AMENDMENT OF SOLICITATION/MODIFICATION OF CONTRACT			1. CONTRACT ID CODE J	PAGE OF PAGES 1 20
2. AMENDMENT/MODIFICATION NO. 0004	3. EFFECTIVE DATE 10-Apr-2015	4. REQUISITION/PURCHASE REQ. NO.		5. PROJECT NO.(If applicable)

14. DESCRIPTION OF AMENDMENT/MODIFICATION (Organized by UCF section headings, including solicitation/contract subject matter where feasible.) Subject: RM 09-1471 Repair Inside Machine Shop Building 431, Naval Base Kitsap, Bremerton, WA Description continues on page two.				
Except as provided herein, all terms and conditions of the document referenced in Item 9A or 10A, as heretofore changed, remains unchanged and in full force and effect.				
15A. NAME AND TITLE OF SIGNER (Type or print)		16A. NAME AND TITLE OF CONTRACTING OFFICER (Type or print)		
		TEL:	EMAIL:	
15B. CONTRACTOR/OFFEROR	15C. DATE SIGNED	16B. UNITED STATES OF AMERICA		16C. DATE SIGNED
_____ (Signature of person authorized to sign)		BY _____ (Signature of Contracting Officer)		10-Apr-2015

AMENDMENT 0004

BUCKLING RESTRAINED BRACE SCHEDULE
NOT TO SCALE

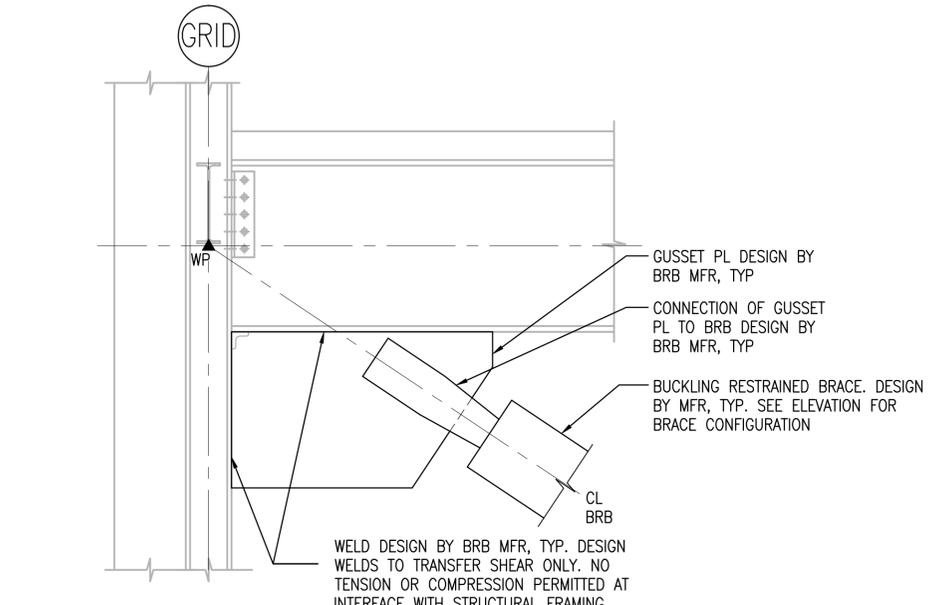
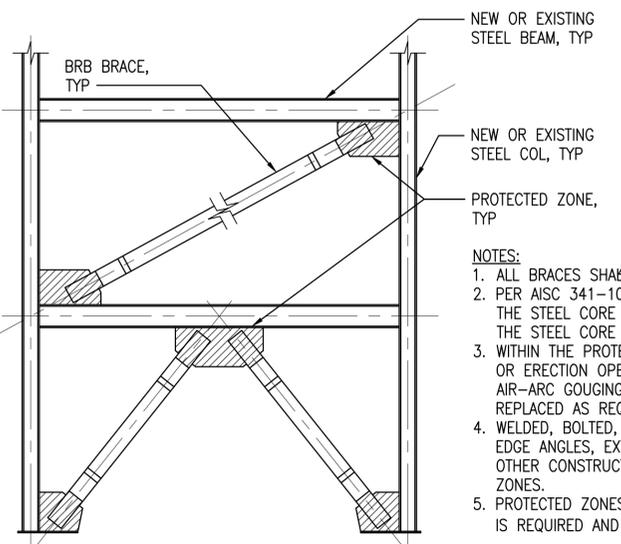
Note 4 on L/S-541 specifies stiffness modification factor of 1.4 for all braces. No tolerance range is provided (+/- 10% is typical). Please provide that allowable tolerance on this factor. Additionally, the stiffness modification factor of 1.4 may likely not be achievable for braces of this length. Some braces would need stiffeners of 360" or larger to get this stiffness factor which may result in undesirable strain levels and perhaps in brace performance that cannot be verified by testing. Please confirm if there will be opportunity to coordinate stiffness values consistent with braces of these lengths once project is awarded.

Revised S-541 is provided to indicate acceptable ranges of KF values based on the brace size and length. The ranges provided include tolerance.
